WALBERTON PARISH COUNCIL
INCLUDING FONTWELL AND BINSTED
Parish Council Office, The Pavilion, The Street,
Walberton, Arundel, West Sussex, BN18 0PJ

Ref: Planning application WA/58/21/PL – Brookview Nursery, Eastergate Lane, Walberton BN18 0BA

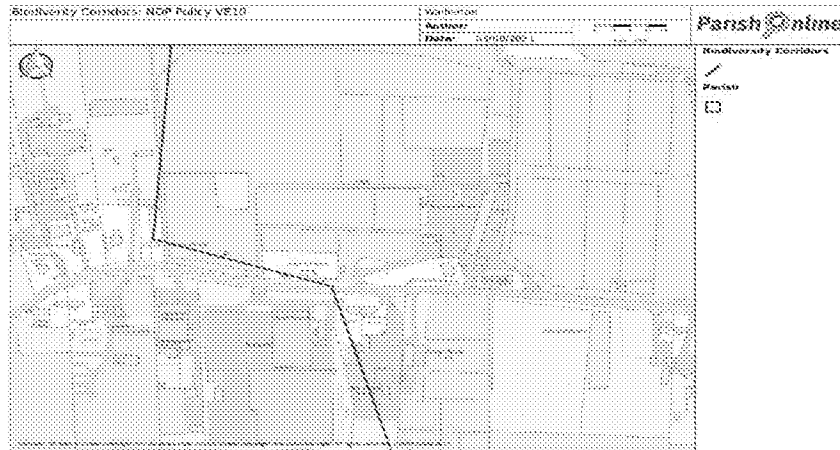
- Policy CL2 of the Walberton Neighbourhood Plan states that, “Change of use of buildings to class B8 will generally be resisted.” This proposal has 431m² of additional class B8 facility.
- The locality has a history of flooding. We are concerned that increased development will increase the flood risk in conflict with Walberton Neighbourhood Plan Policy VE7. The area most recently flooded in March 2020:
